Submission to

DEPARTMENT OF PLANNING AND ENVIRONMENT

**IMPROVING APARTMENT DESIGN AND AFFORDABILITY
- STATE ENVIRONMENTAL PLANNING POLICY NO. 65**

31 October 2014

Figure 1 : Draft Apartment Design Guide - Performance criteria 3F-2

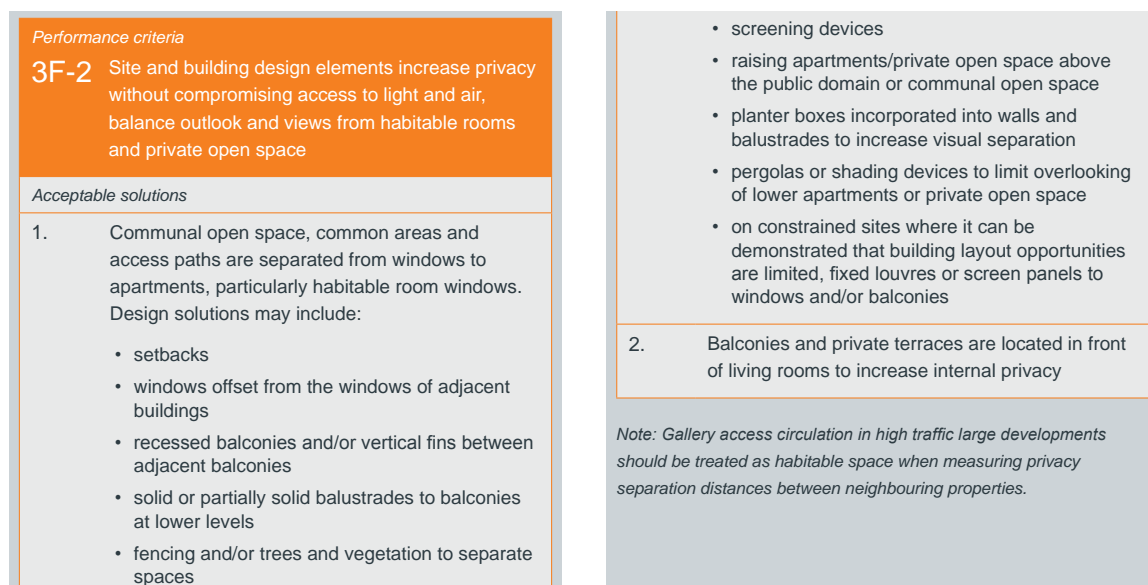
This extract shows that a development can provide a setback, but it can also provide screening devices. Does it mean that the setback is no longer required if the screens are installed? This could lead a poor design outcome across the NSW as the setback is just given as an option rather than a requirement. However if the control was that the setback to the public footpath or communal open space was required up to min of Xm in front of a window. If this setback is limited due to constraints of a site an alternative solution can be proposed and reviewed under a merit of a particular design, such as a smaller setback plus the screens etc. Otherwise this performance criteria allows each development to have screen on each window that faces public domain. It also encourages elevating ground level above the eye level. Both of these would be detrimental to the design and activation of residential developments.

Figure 2

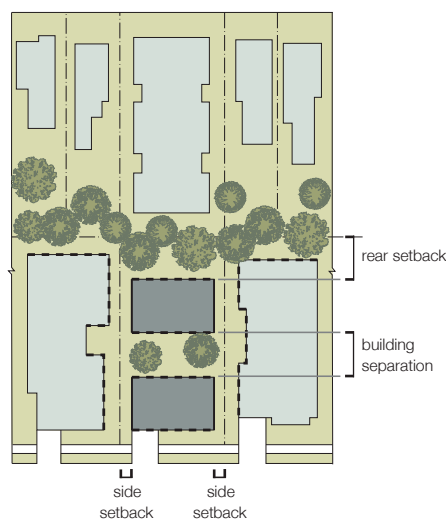
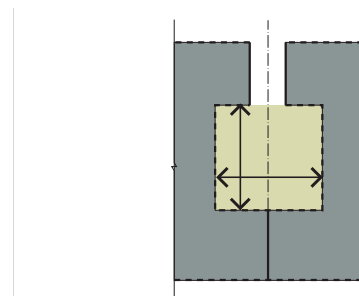
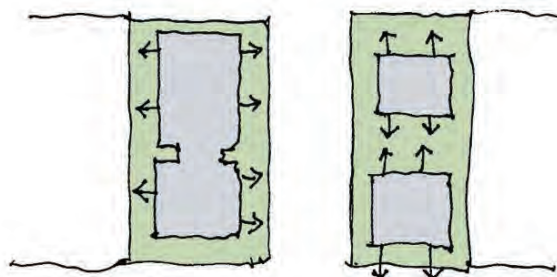
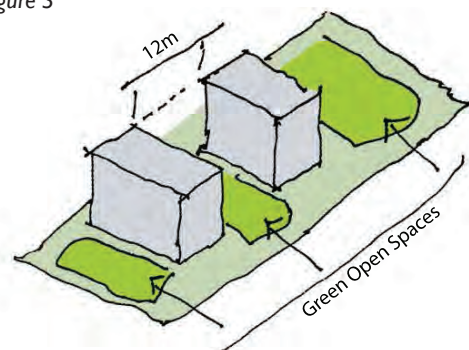
The diagram on Page 18 under Narrow infill apartment presents a built form typology that will lead to numerous privacy and outlook issues. This model was previously discouraged in the RFDC. An improved response would be to adopt a form that includes two buildings that don't overlook the adjoining properties and their communal open spaces/private open spaces (as shown in Figure 2, 4 and 5 below).

If this typology is still to be included, then an alternative solution which should be proposed in the guide is to encourage Councils to include a minimum lot width for this type of development so that issues related to privacy, open space and separation can be achieved. The lot width would need to take into account the maximum depth of a building and a 50% of a separation distance for habitable rooms depending on the height of a building.

Diagram 3 is taken from the current RFDC and this diagram should be retained in the new ADG. Diagram 4 is the solution to deal with the proposed approach illustrated in the diagram on page 18 of the ADG. However this causes issues of visual privacy

Figure 6

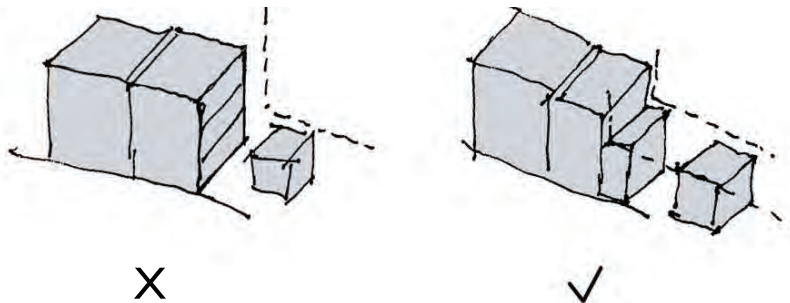
The diagram on Page 19 under Row apartments has the potential to be misleading to the generally encouraged practice of providing built form transition to lower scale buildings. If this building is in a transition area this needs to be clearly shown in a diagram with at least a diagrammatic outline of a potential new envelope on both – the elevation diagram and the axonometric view.

Other diagrams or scenarios that should be included under this paragraph would include a row apartment typology adjacent to a low scale zone. In this case the diagram should include a stepping form along the side boundary as represented in Figure 6 below.

Figure 7

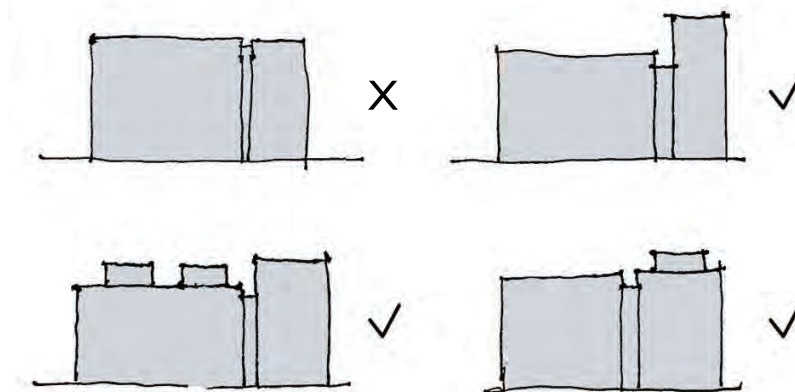
Diagram under Perimeter Block (Page 20) shows a expansive wall along the corner with little roof profile articulation. Better diagram would include a built form as shown in Figure 7 below. The requirement of built form vertical articulation should be strengthened in the discussion under this subchapter.

Figure 8

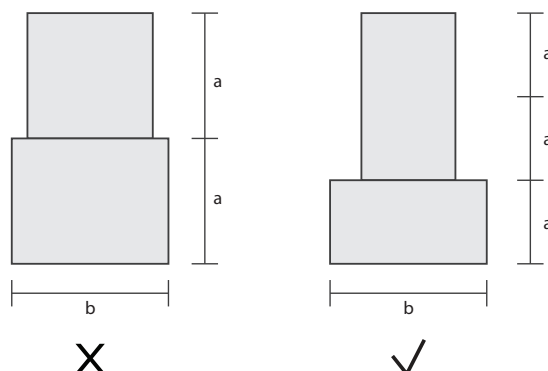
The tower apartment section requires a discussion about the tower height proportion/relation to the podium height. For example a tower of 16 storeys would not be well proportioned if it was positioned on an 8 storey podium, but would be more appropriate if the height of the podium was 6 storeys vs 10 storey tower. It is also important to take into account the width of the tower versus its height. Again, a tower of 8 storeys equalling to approximately 24m height would not be well proportioned to a width of 24m (equal to the height), but a narrower (at least by 2/3) or wider tower would become more appropriate. This is represented in Figure 8 below.

Figure 2A.1 Key considerations when testing development controls and establishing a three-dimensional building envelope

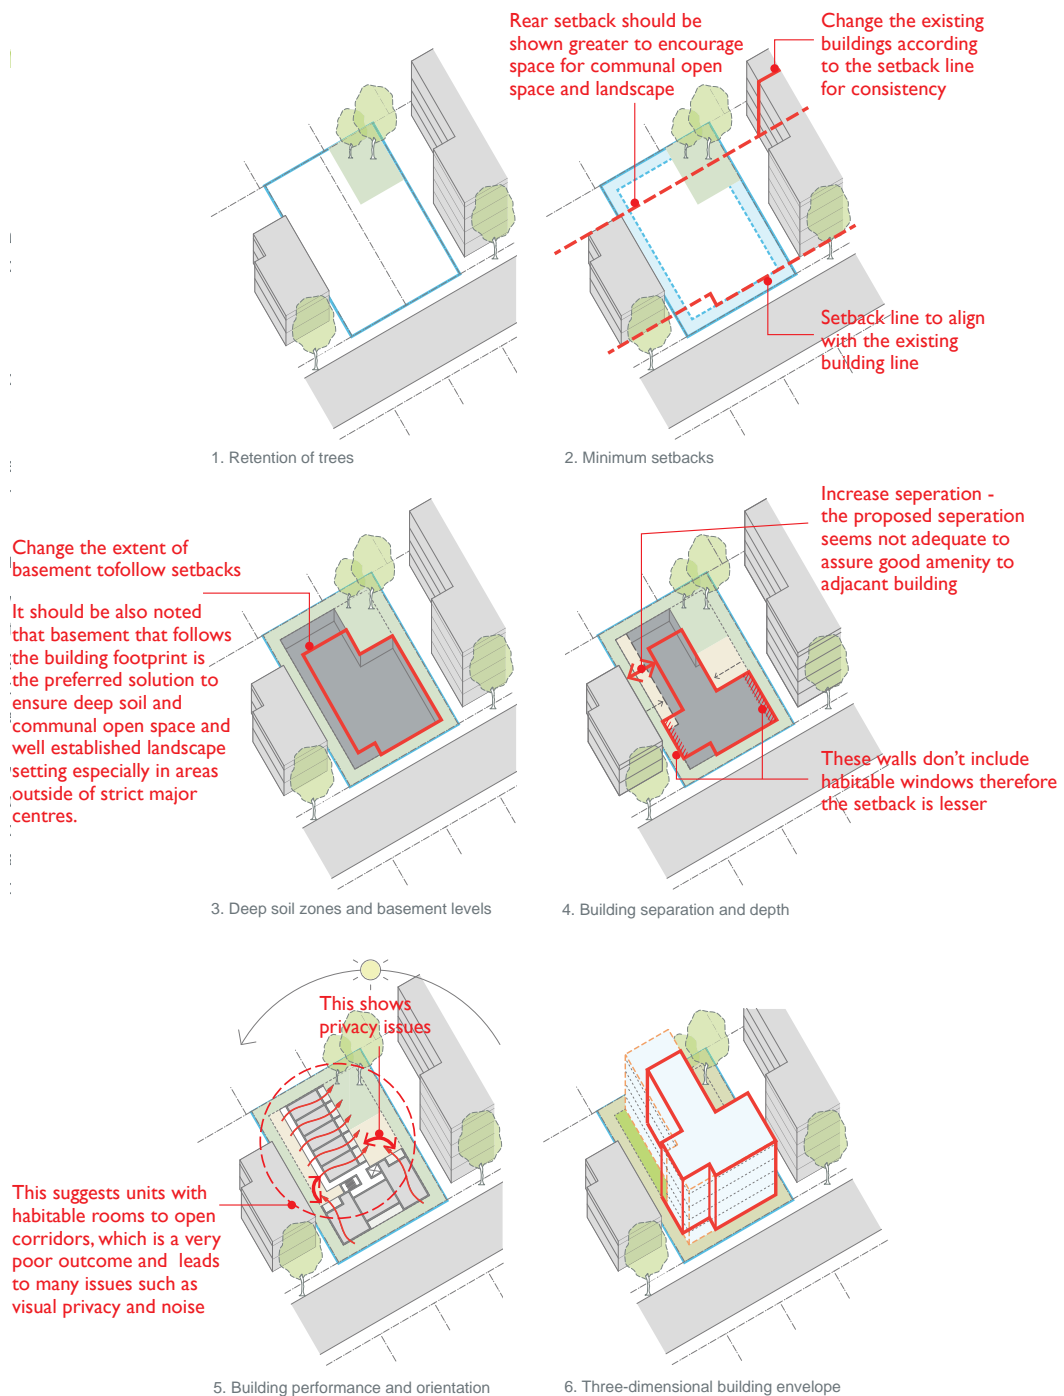
The diagrams accompanying the text on page 30 also require some amendments. The specific mark ups are provided below in Figure 11.

Figure 12

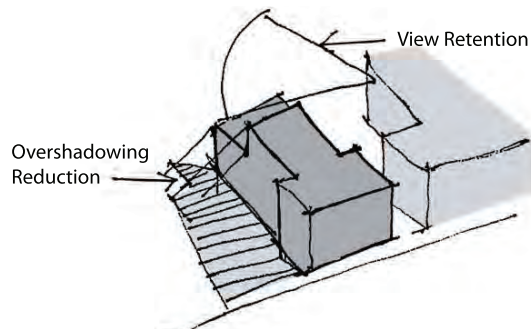
Under 'Setting and Testing the Controls', there is no mention given to neighbouring outlook and the potential view loss. It is one of the Land & Environment Court's key principles. It is suggested that diagram 6 on page 30 be followed by another diagram showing how a skillful design can retain some of the views and part of the outlook to the neighbouring properties. The suggestion of this interpreted in a simple diagram is provided below in Figure 12.

Figure 2B.2 Building envelopes define the 'container' within which a building is designed. They are a useful tool to gain an understanding of the future urban form and scale of an area, however they do not represent buildings and are typically 25-30% larger than the final built form

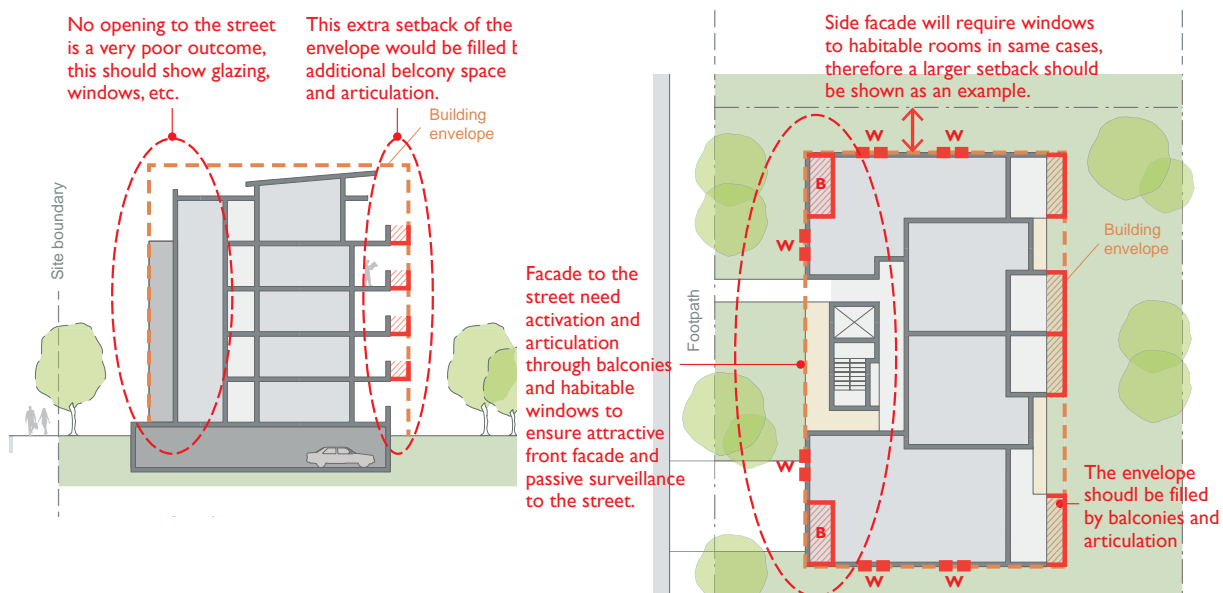
The diagrams on that page 31 are also not fully supported and require some amendments as per suggestions in the mark up below in Figure 13 below.

Figure 2F.2 Alternatives to respond to built form corners, location of access cores, building separation and apartment configuration

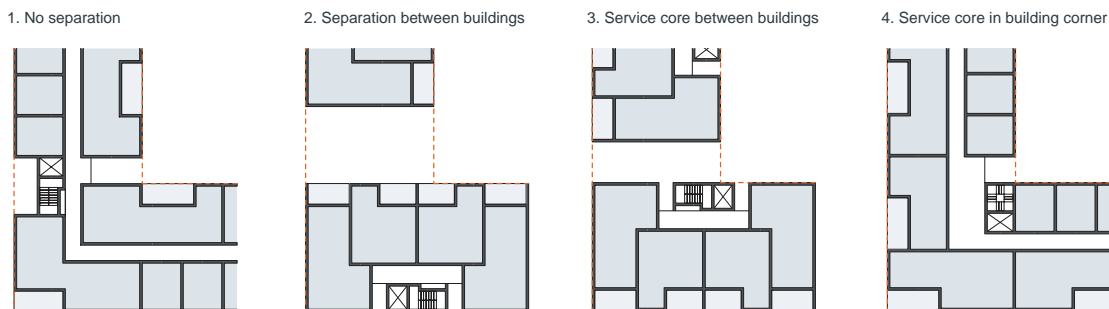
Diagram on page 38 Figure 2F.2 does not distinguish between walls with windows and blank walls, so as to incorporate privacy impacts or principles to separation. This is critical as it will reinforce the issue that privacy must be maintained when providing alternatives to separation distances.

The purpose of this is not clear. Please include location of street and rear and side setbacks as well as location of windows and relationship to adjoining properties.

Figure 15

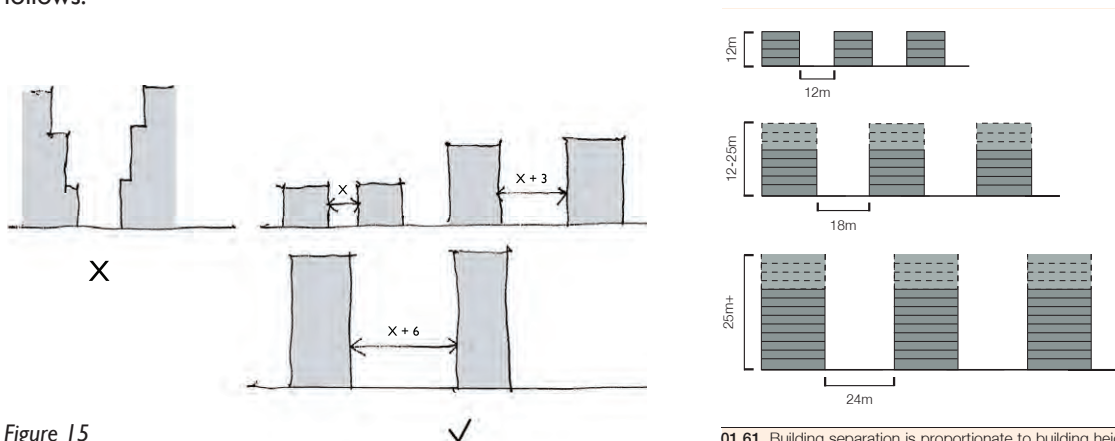
A review of the RFDC (and replacement with an improved version –ADG) should be the golden opportunity to revise and finally get rid of diagram Figure 2F.4 (page 39) which shows a 'wedding cake' outcome with regards to the application of the separation distances. The previous diagram (shown in Figure 15) that showed the dimensions being applied to the totality of the elevation according to the height is for greater outcome and it should be included in this modification to the policy. The diagram should be amended as follows:

Figure 2G.4 Street setbacks should be consistent with existing setback patterns in the street or setbacks that achieve the desired future character of the area

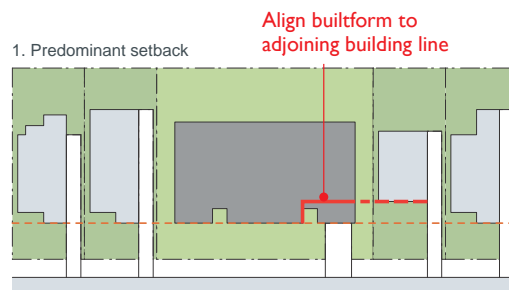
Figure 2G.4 - includes the diagram 1. Predominant setback, which should be amended to include a step in building footprint to align with the setback of the adjoining building as indicated in Figure 16 below:

Figure 2H.2 On infill sites, following the existing open space patterns, limiting side setbacks and locating habitable rooms to face the street and rear boundary optimises amenity and privacy for all

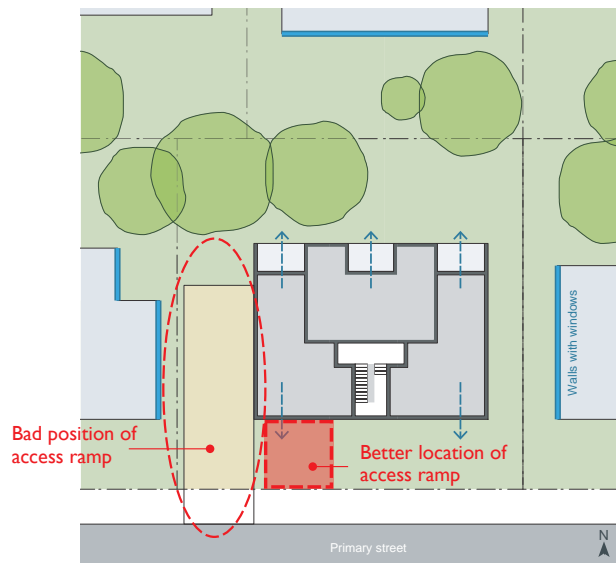
The diagram on page 42 Figure 2H.2 suggests that the side boundary is occupied by an exposed access ramp. This is an outcome that compromises outlook and visual amenity. It generates acoustic and pollution impacts. The access ramp needs to be shown either with a setback to the building or accessing under the building footprint.

Figure 2H.3 On narrow infill sites, select a building type that orientates habitable rooms to the street and rear, minimising required side setbacks

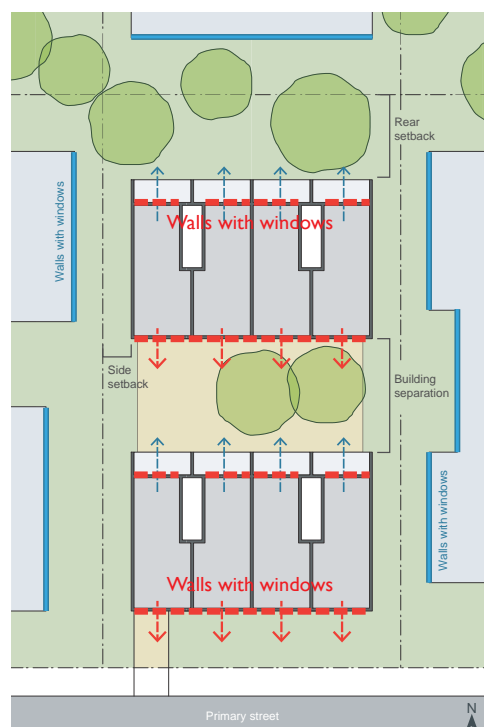
The diagram on page 43 – Figure 2H.3 poorly describes the best outcome. It indicates the outlook from balconies to the rear and the central paved area (same colour as driveway) with the walls to the street shown as blank and unarticulated. Certainly this is an oversight as this will not be a good outcome. The row of units facing the internal space also look out to a blank wall on the building to the north active walls are shown in this diagram as being thicker with blue lines. This is not the case for the critical walls facing the primary street and the southern wall of the northern building facing the central open space. We suggest the amendment to this diagram as shown in the diagram below (Figure 18).

Figure 2H.4 Where limited setbacks and deep buildings are unavoidable, 'step in' the plan layout to create internal courtyards for improved privacy and daylight access

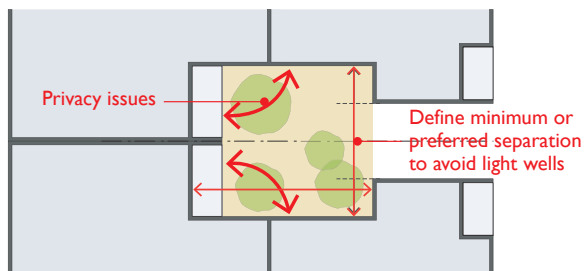
Figure 2H.4 indicates that a courtyard development is encouraged. This figure is similar to the existing RFDC figure 01.77. Both of these diagrams are possibly misleading and give the wrong impression that a light well for constrained sites is appropriate. It is therefore important to include specific dimensions or explanation regarding the minimum width and depth of a lightwell to avoid misinterpretations.

Figure 20

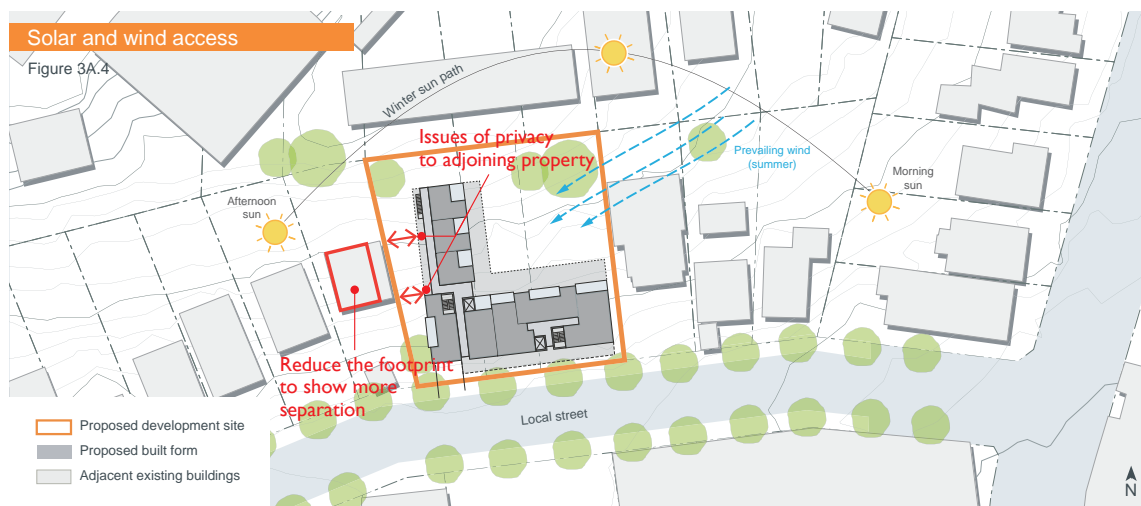
Some diagrams in this section are also not clear and need further development or amendment. The mark up of specific issues is provided below (Figure 20 and on the next page in Figure 21).

Figure 3B.2 Building orientation and height influences solar access to apartments and common open spaces. On south facing slopes, orient the rear wing of the building(s) east to west to maximise solar access, on north facing slopes, step building(s) with the slope.

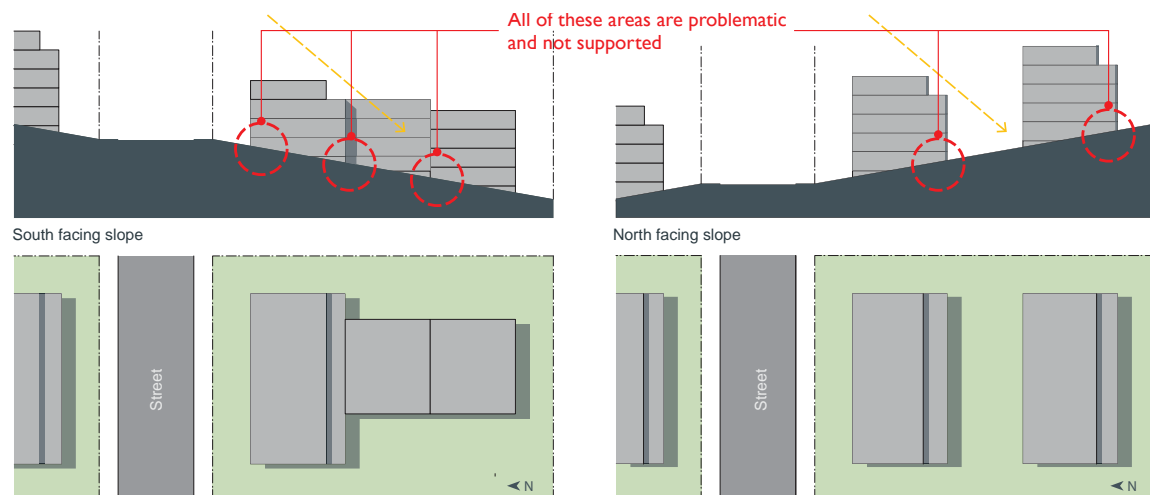
Figure 3B.2 – show some issues regarding units under ground, which shouldn't be advocated in this document. The mark up is provided below (Figure 22):

Figure 23 - Ear Window

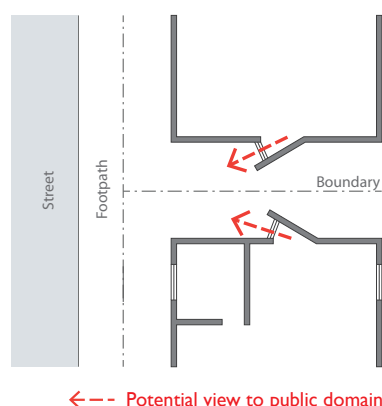
The solution such the 'ear windows' should be also included as one of potential solutions for redirecting the view. An ear window solution is presented below in Figure 23:

Figure 28 - Better example of providing two cores and more opportunities for dual aspect units for a single building

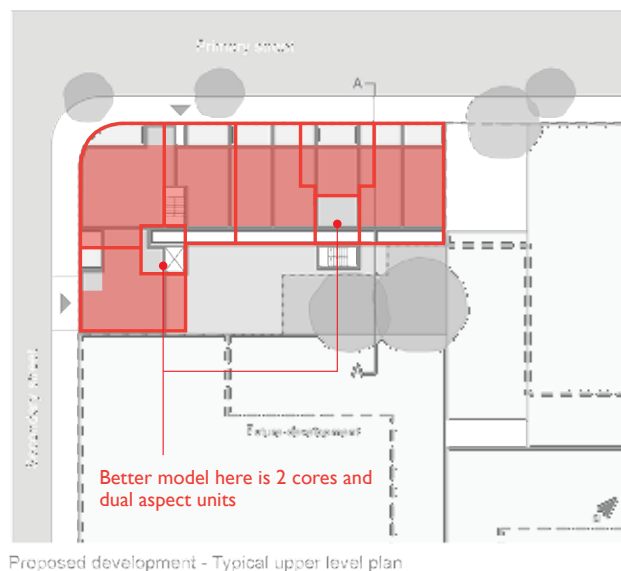
Large number of units shown in the examples (Figures 4M.3-4M.6) are single aspect. This document should encourage the design that involves dual aspect and corner units. An example of providing two cores for a single building and therefore providing more opportunities for dual aspect units is provided below (Figure 28):

Example 06 - Perimeter block apartments

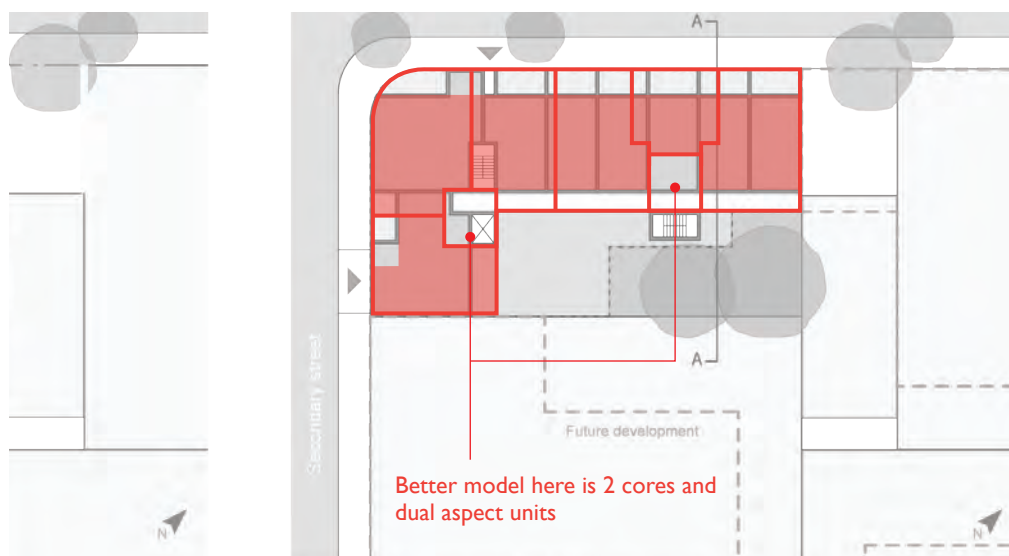
This example is wrong. The Apartment Design Guide should discourage designing open walkways to habitable rooms. This should be treated similarly to single aspect units. The example should be replaced with a development with multiple cores and a maximised number of dual aspect and corner units. The example of that is provided on the next page in Figure 29:

Figure 30 - Poor courtyard solution

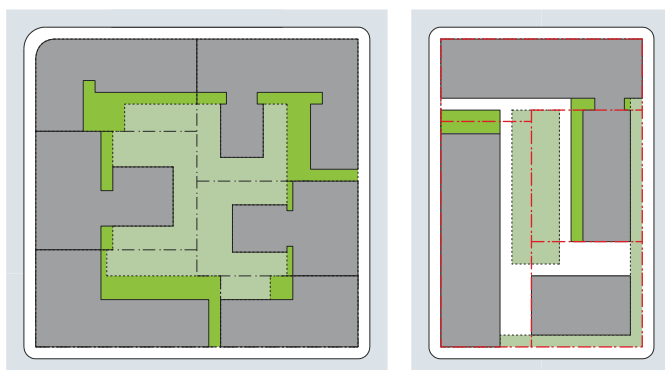
The diagram on the bottom left on page 164 (shown below) can be dangerous and should be strictly limited to high density areas in the strict centres.

The courtyard shown in this diagram is very narrow and could assume lightwell solution. Perhaps it would be better to show a real example in a photograph or larger separations could be provided as this is supposed to be the best example for the industry.
